DEVELOPMENT REVIEW COMMITTEE (DRC) COMMENT REPORT

PROJECT NAME: Fort Lauderdale Police Headquarters

CASE NUMBER: UDP-S21029

REQUEST: Site Plan Level IV Review: Public Purpose Use Request:
191,000 Square Foot Police Facility with Setback
Modification and Parking Reduction Request

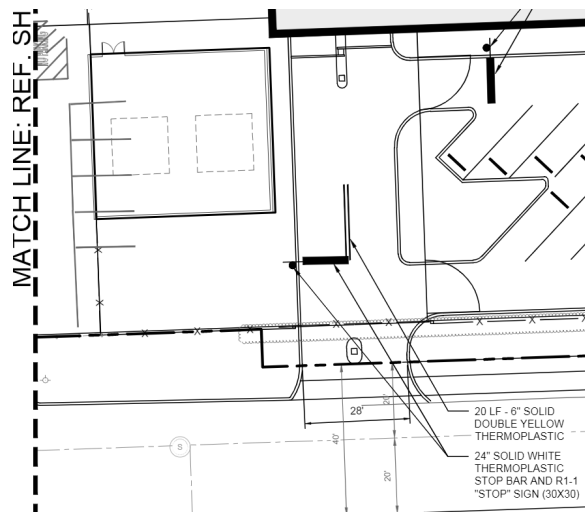
- k. Clarify if fence will divide confiscation parking area on pages PG-A2-01, CM-104 and LP-104 and if there is an opening. See clipped image below.

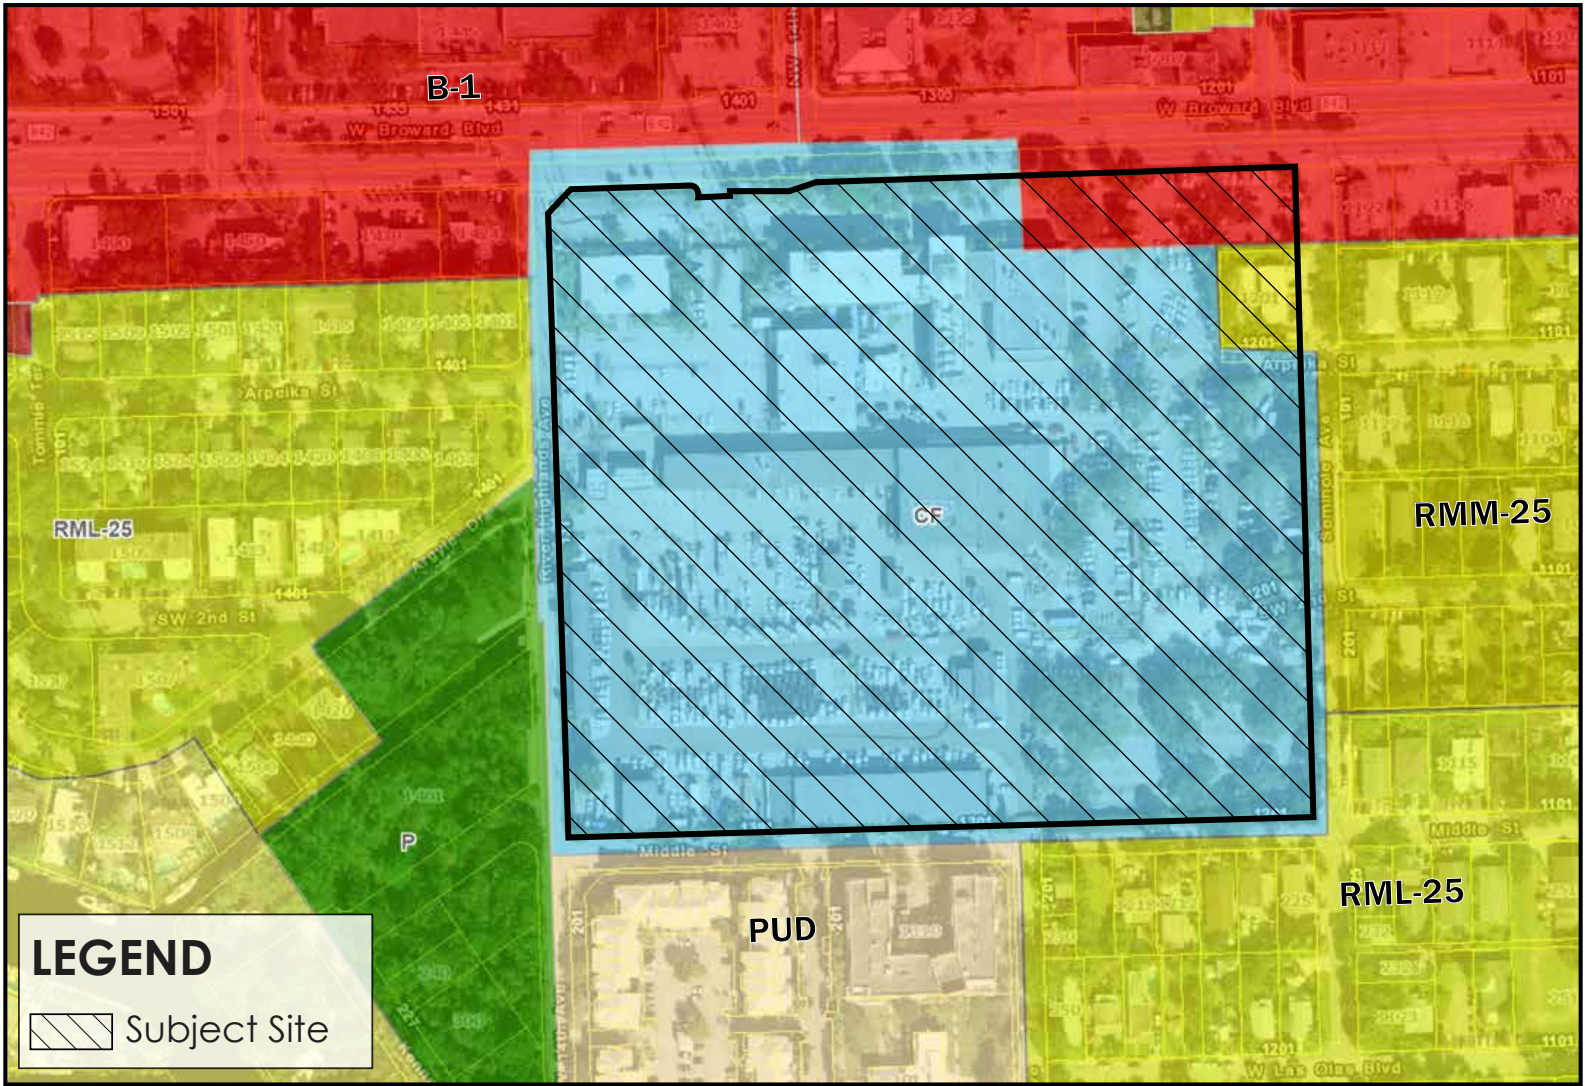
To increase compatibility with the neighborhood, consider the following additions to the site plan:

- o. On-street parking on Middle Street between SW 13th Avenue and SW 14th Avenue.
- p. Crosswalk and northbound and southbound stop signs at the intersection of SW 14th Avenue and Middle Street.
- q. "Do Not Block Intersection" pavement markings to facilitate egress/ingress to Argyle Drive.
